Islam Garments Ltd. (Knitwear Division) (Extension)

Block-F, Holding # 119/1, Jarun, Konabari, Gazipur
(23.995441, 90.327008)

6 November 2023

No compression strut in the long direction

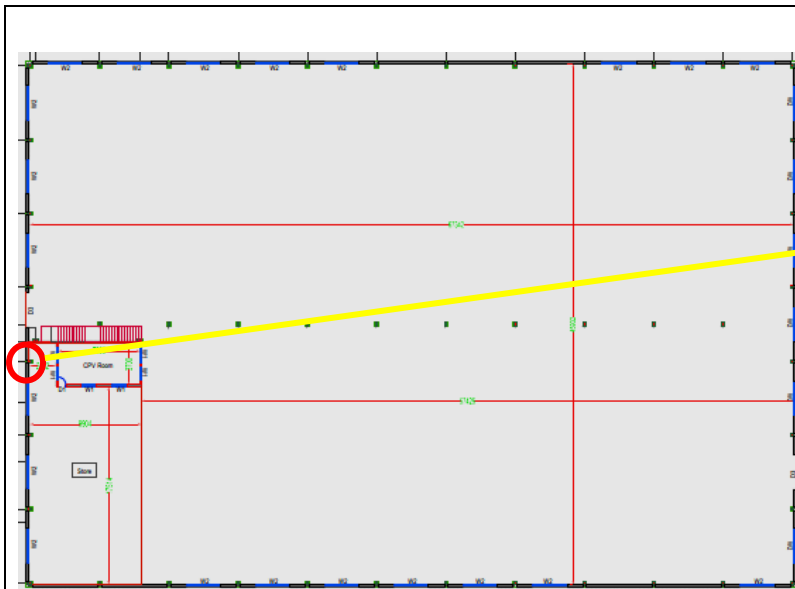
Observation 1: Lack of lateral stability system.

Description: Portal frame was observed in the short direction. Compression strut or load transfer media was not observed in the long direction.

Observation	Action Plan	Timeline
Lack of lateral stability system. (Shed-9)	Building engineer is required to check the lateral stability of the shed as part of the Engineering Assessment (EA).	within 6 weeks
	Carry out remedial work where required.	within 6 months
Mismatches in as-built drawing. (Shed-9)	Building engineer is required to prepare accurate as-built drawings as per site condition.	within 6 weeks
Load Plan not prepared for the Mezzanine floor. (Shed-9)	Building engineer is required to produce load plan for mezzanine floor.	within 6 weeks
Perforation on steel column. (Shed-9)	Building engineer is required to rectify the perforated area of steel columns by a suitable method.	within 6 weeks
Loose roof bracing. (Shed-9)	Tighten the loose bracing.	within 6 months
Corrosion on steel members. (Shed-9)	Apply rust proof paint on corroded members.	within 6 months
Absence of lateral stability. (Shed-17)	Building engineer is required to check the lateral stability of the shed as part of the Engineering Assessment (EA).	within 6 weeks

Steel column schedule

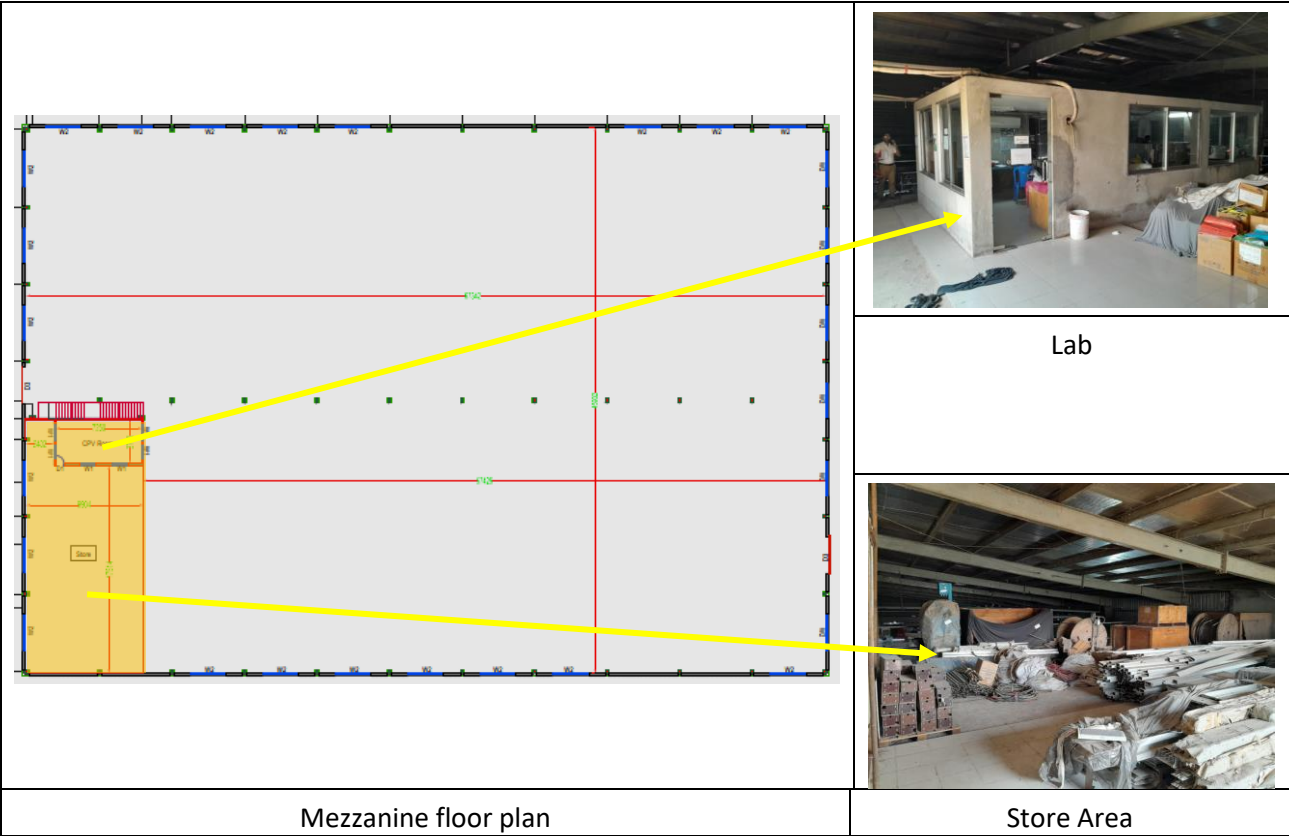
Observation 2: Mismatches in as-built drawing.

Description: Flange thickness of SC-1 column was found 7.3 mm instead of 8mm.

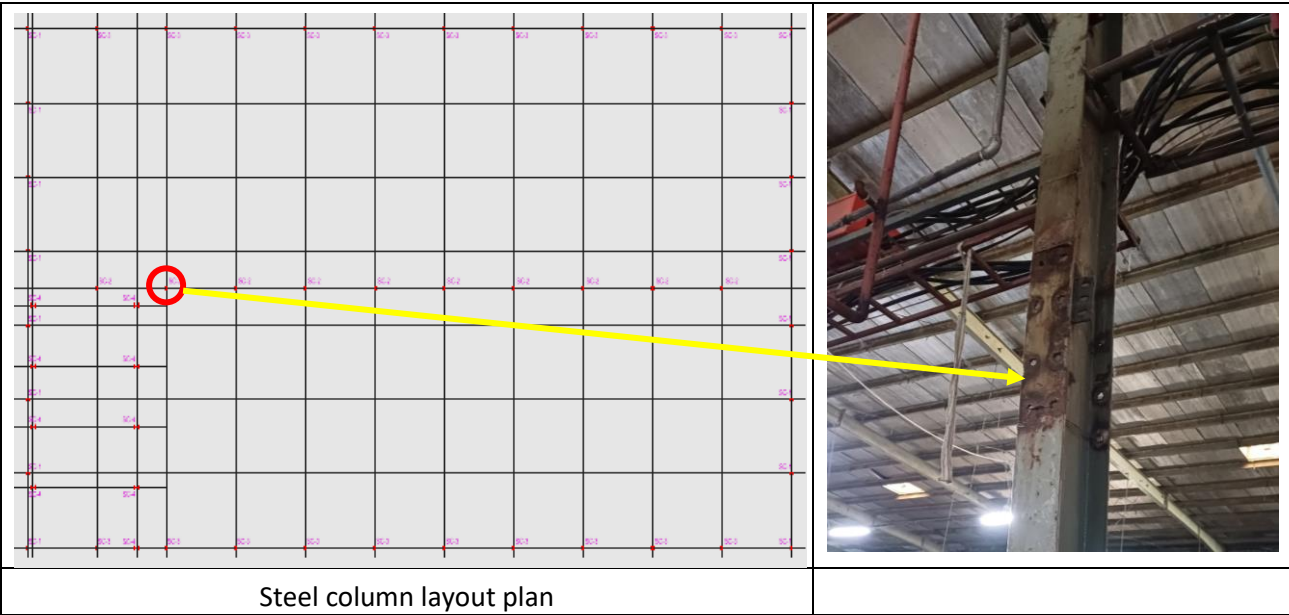
Observation-3: Load plan not prepared for the mezzanine floor.

Description: Load plan was not prepared for the mezzanine floor.
